PLAN-024138

Proposal: Replacement front porch.

Site: 3 Nursery Cottages, Barnham Lane, Barnham, PO22 0JJ.

BN/39/18/HH

Southern Water MapGuide Browser

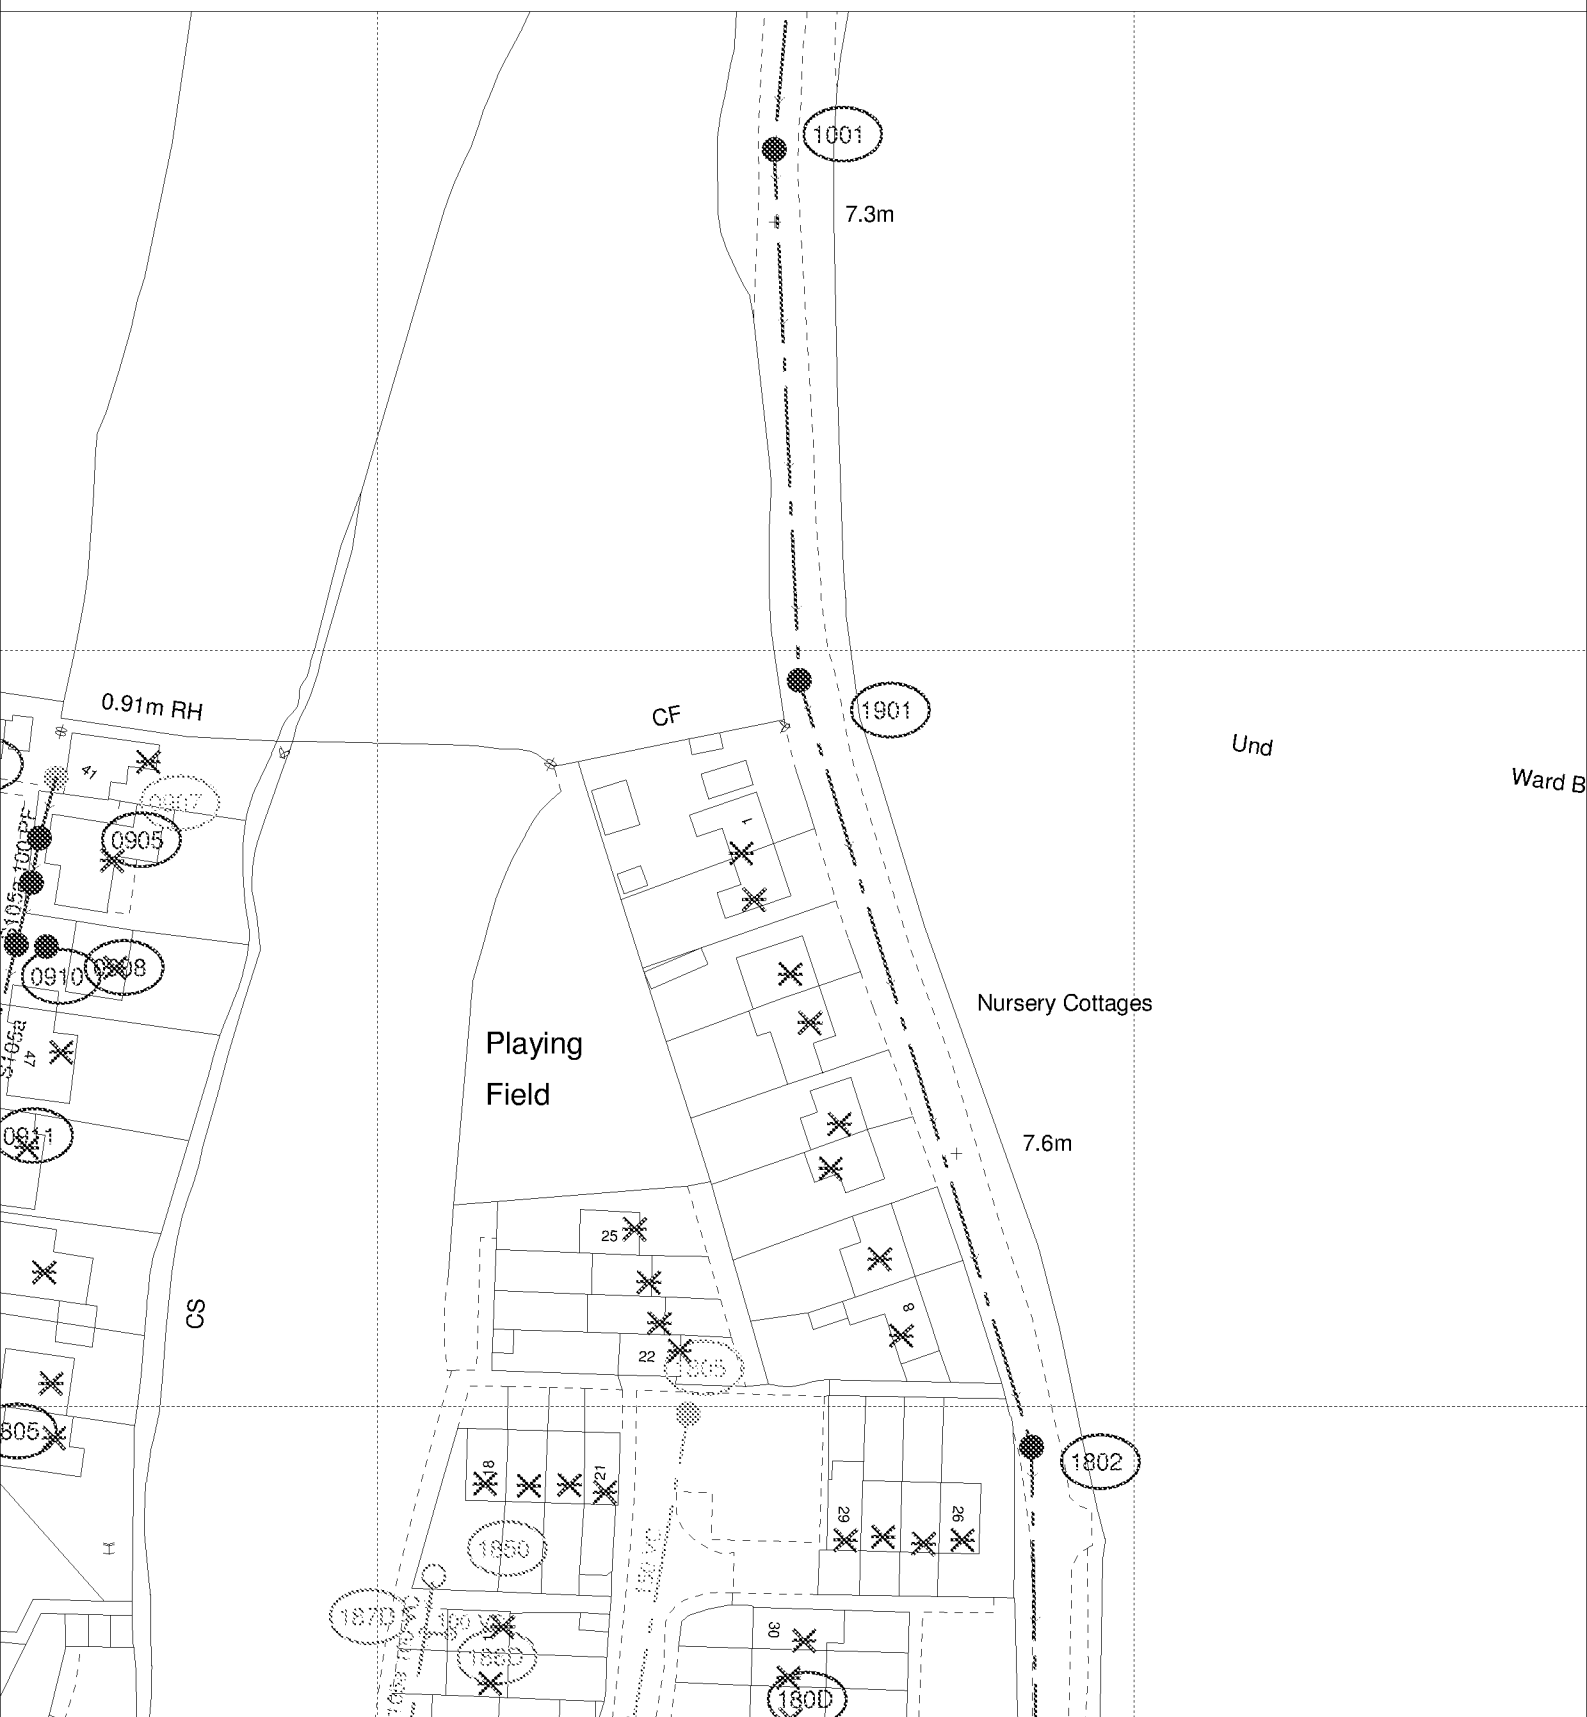
Due to changes in legislation that came in to force on 1st October 2011 regarding the future ownership of sewers it is possible that a sewer now deemed to be public could be crossing the above property. Therefore, should any sewer be found during construction works, an investigation of the sewer will be required to ascertain its condition, the number of properties served, and potential means of access before any further works commence on site.

Due to surface water inundation issues in the Lidsey Catchment "The applicant is advised to adopt, where appropriate, the measures in the table "Practical measures to reduce the potential impacts of development".

Developer should look to protect the public sewerage system from inundation and infiltration, which contribute to flooding in unfavourable conditions.
